# DEVELOPMENT REVIEW COMMITTEE (DRC) COMMENT REPORT

**PROJECT NAME:** 101 SE 7th Street

**CASE NUMBER:** UDP-S22056

**REQUEST:** Site Plan Level II Review: 630 Multi-Family Residential Units and 5,682 Square-Foot of Commercial Use in the Downtown Regional Activity Center

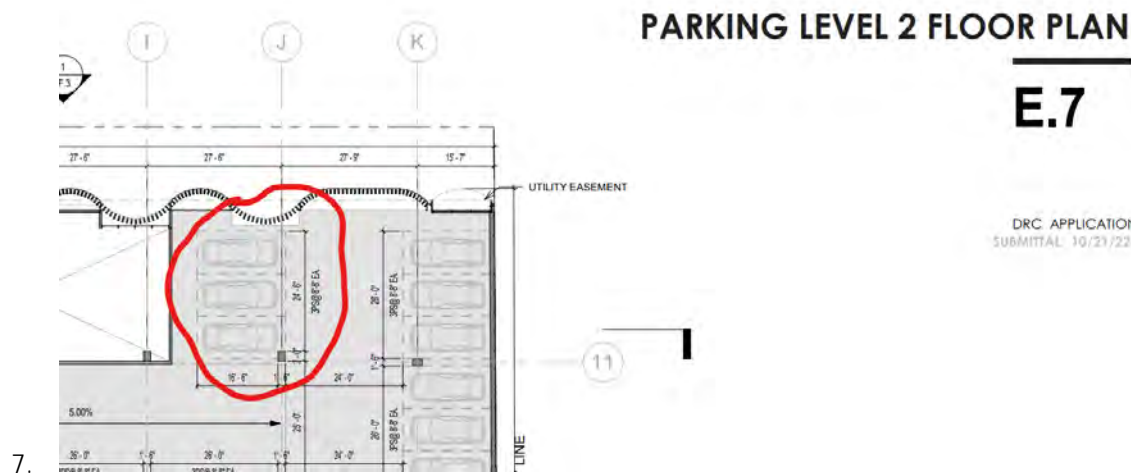
6. The three parking stalls on the northeast corner of the parking garage on sheet E7 do not meet the parking dimensional requirements and it appears a column is within the dimensioned area see image below. Please correct the dimensions so that they meet our city requirements.

### **SE 6th Court**

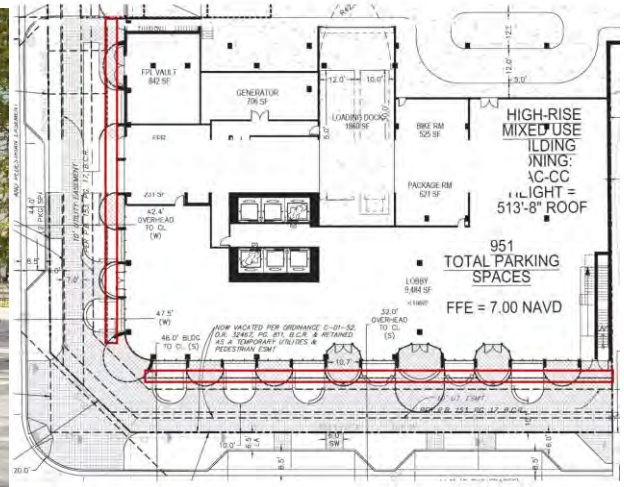
The total measurement of the ROW is 30 feet near the corner of SE 1st Avenue and SE 6th Court; but the measurement is 25 feet at the eastern property line. Consistency of the ROW should be maintained along the entire frontage and align with the new development to the east which shows a 30-foot ROW.

### Storefronts

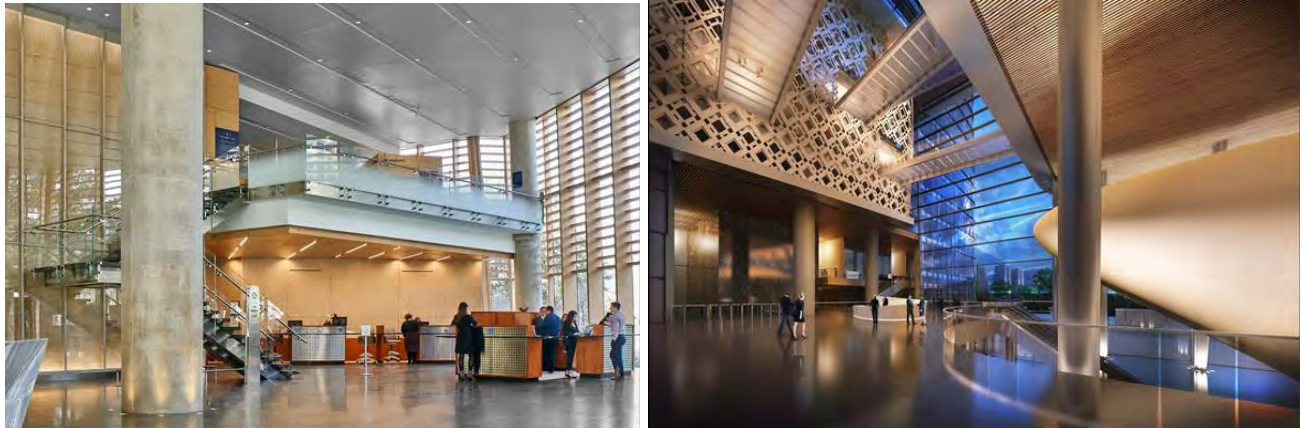
- k. **SF2, SF3**, A combination of storefront styles with a combination of durable materials to create variety and visual interest should be incorporated at the street level. Create a varied storefront design along SE 6th Street and consider incorporating an arcade as part of the storefront design by pushing the building wall back to allow for the placement of shading devices.
- l. **SF 6**, See comments under B2, B12, and B15. Consideration should be given to the incorporation of a pedestrian arcade with the and to opening up the building at the corner of SE 7th Street and SE 1st Avenue to provide a public plaza area.
